**FINDINGS AND RECOMMENDATION
OFFICE OF PLANNING AND ZONING
ANNE ARUNDEL COUNTY, MARYLAND**

CASE NUMBER: 2024-0054-V

REQUEST

The applicant is requesting a variance to allow identification signs for the name of a tenant in a business complex on more facades than allowed on property located at 7941 Ritchie Highway in Glen Burnie.

LEFT ELEVATION

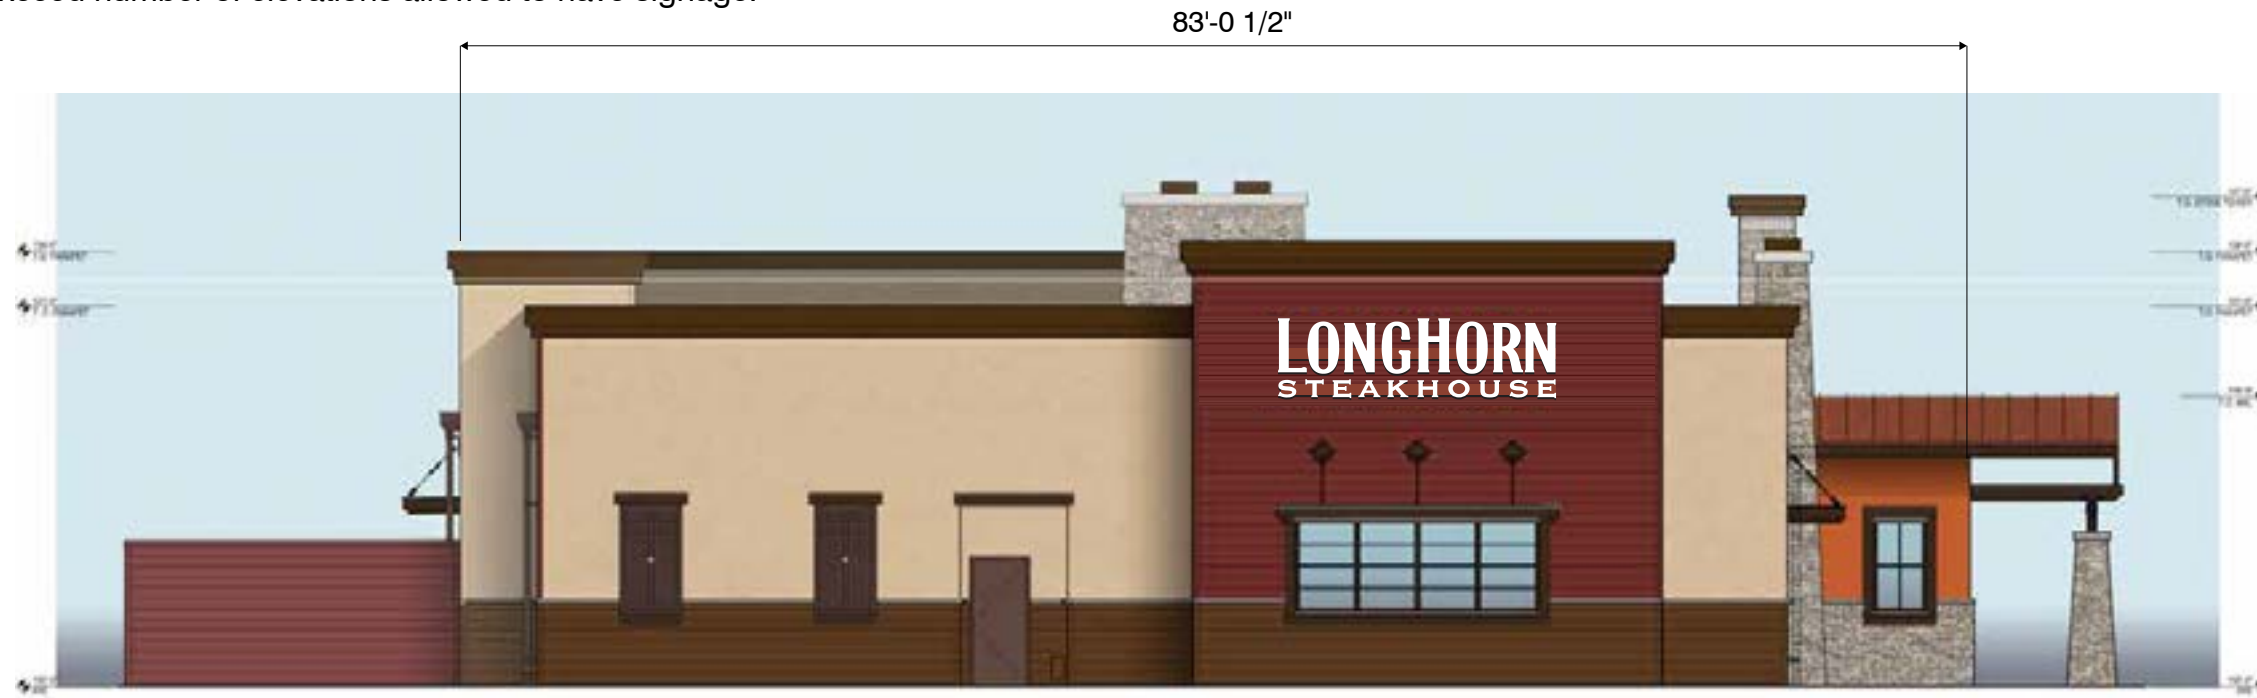
As such, the requested variance is not considered the minimum necessary to afford relief and this Office cannot support the variance for the additional signage, as proposed.

Variance Required

Variance required to exceed number of elevations allowed to have signage.

REAR ELEVATION

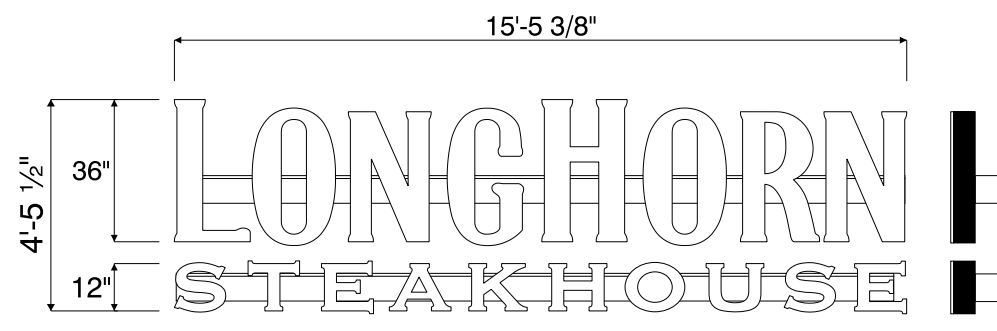
Variance Required

Variance required to exceed number of elevations allowed to have signage.
